# CITY OF ALBUQUERO

RE: **Sequoia Apartments** 8100 Sequoia Rd. NW **Grading and Drainage Plan** Engineer's Stamp Date: 02/22/2022 **Hydrology File: G11D058**

Based upon the information provided in your submittal received 1/4/2022, the Grading & Drainage Plan is not approved for Building Permit. The following comments need to be addressed for approval of the above referenced project:

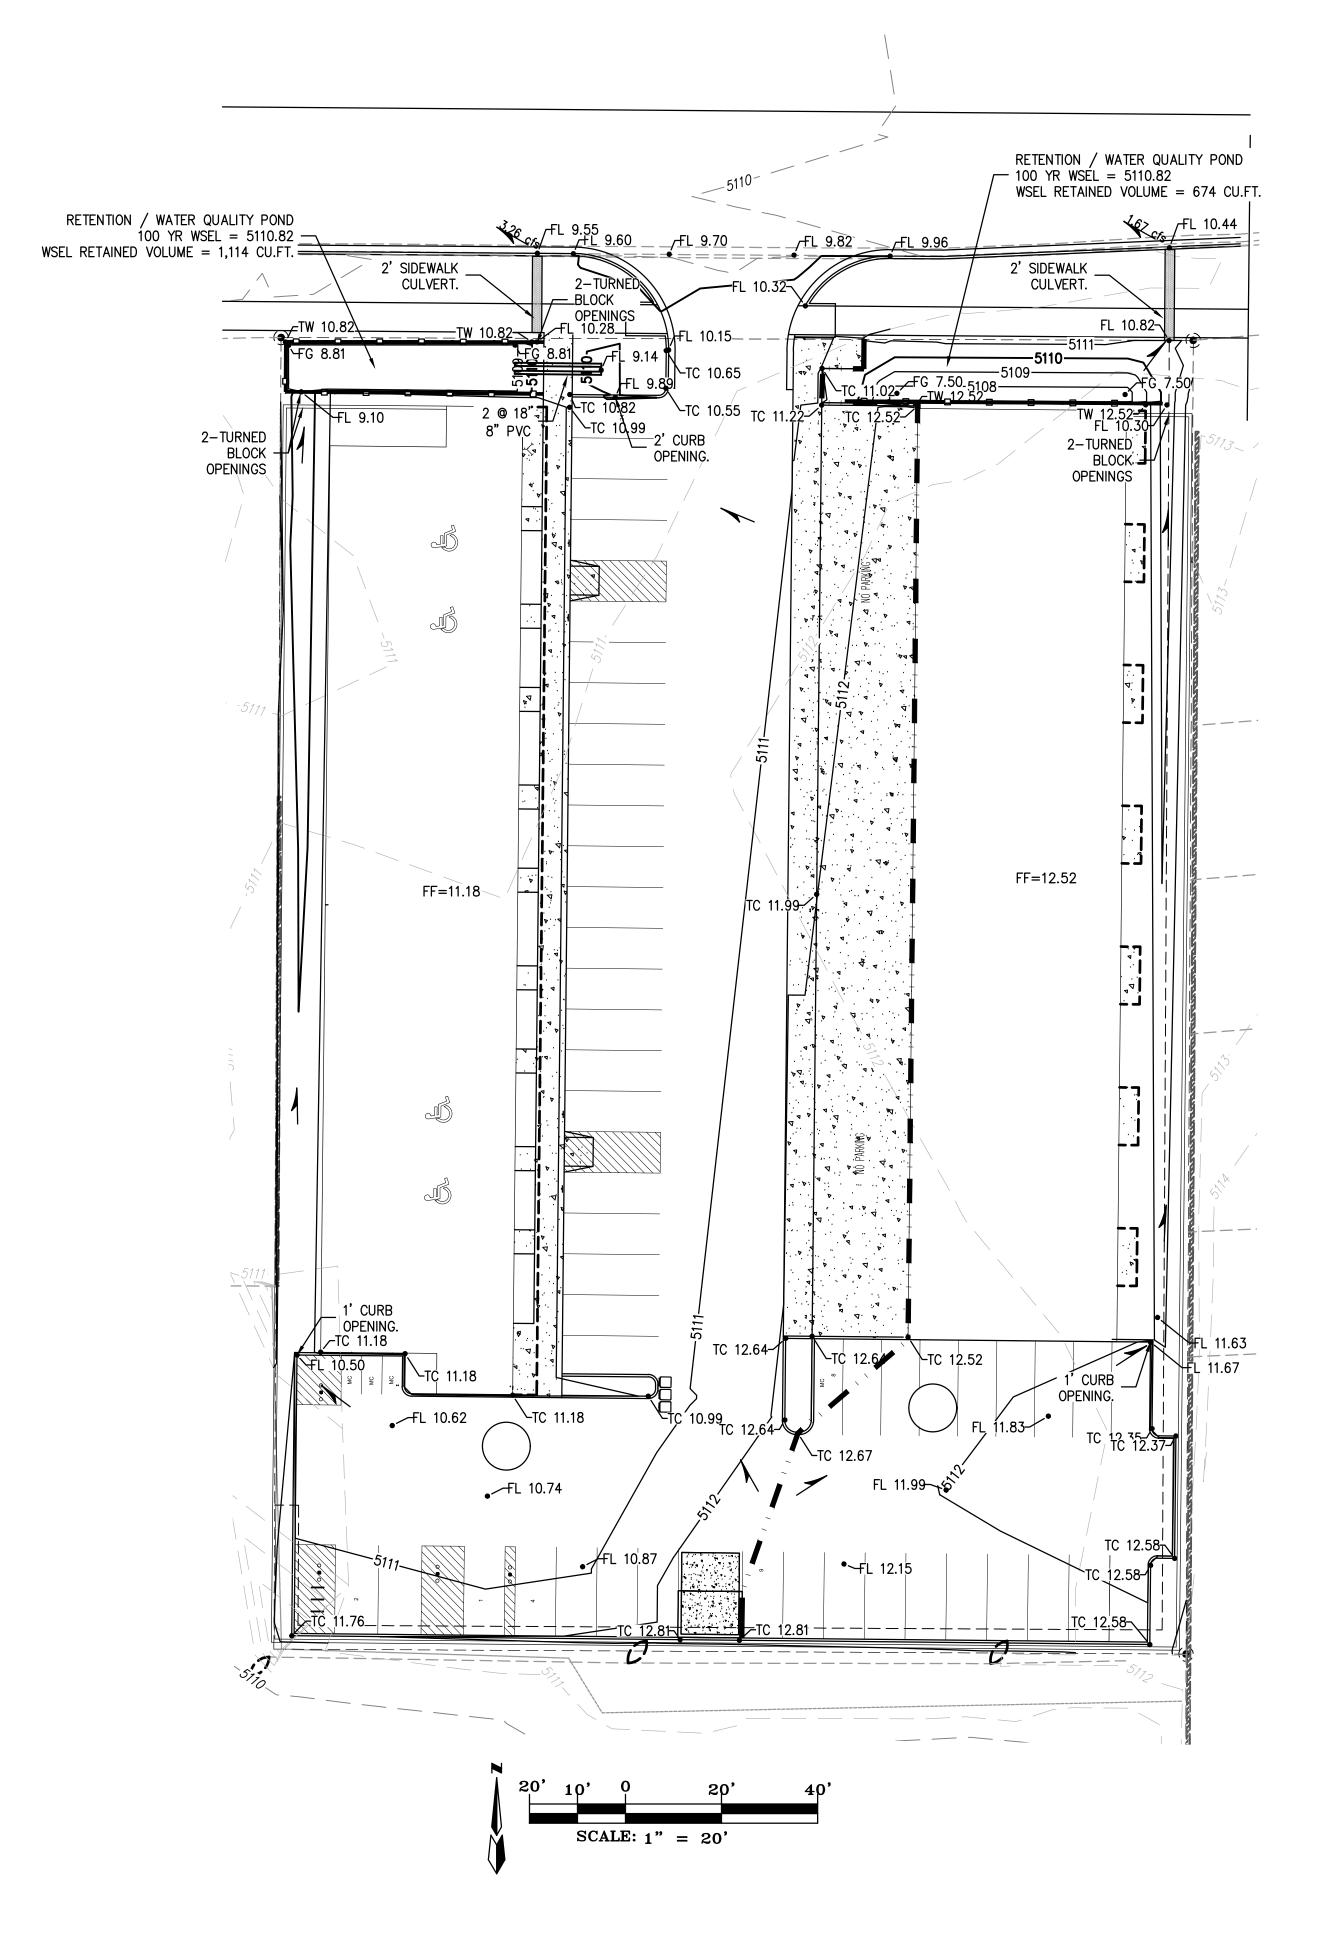
1. Please provide swale details.

- 2. Please include the survey data.
  - a. What are you tying into.
- 3. An SO-19 Permit will be required and should be included on the request. Please include the standard SO-19 notes on the grading plan. (attached)
- Please include the street name

5. What are these circles?

- 6. Please provide sections of the ponds with water surface elevations of storage for the 100
- 7. Reference standard details (drive entrance with proper water block check existing elevations – and sidewalk culverts)
- 8. Please include project benchmark and datum.
- 9. Retention is 100 year 10 day volume. If you are going to call out retention, please provide the proper calculations. If it is SWQV, simply state such.
- 10. Is there a basin break? If so please label the line separating them. It is not clear.
- 11. Show the roof flow direction and where it discharges to.
- 12. Please update your notes. You are calling out update no 8. Etc... Please take a look.
- 13. Please provide inverts on the pipes connecting the larger pond. And please label the ponds for reference to requested sections.
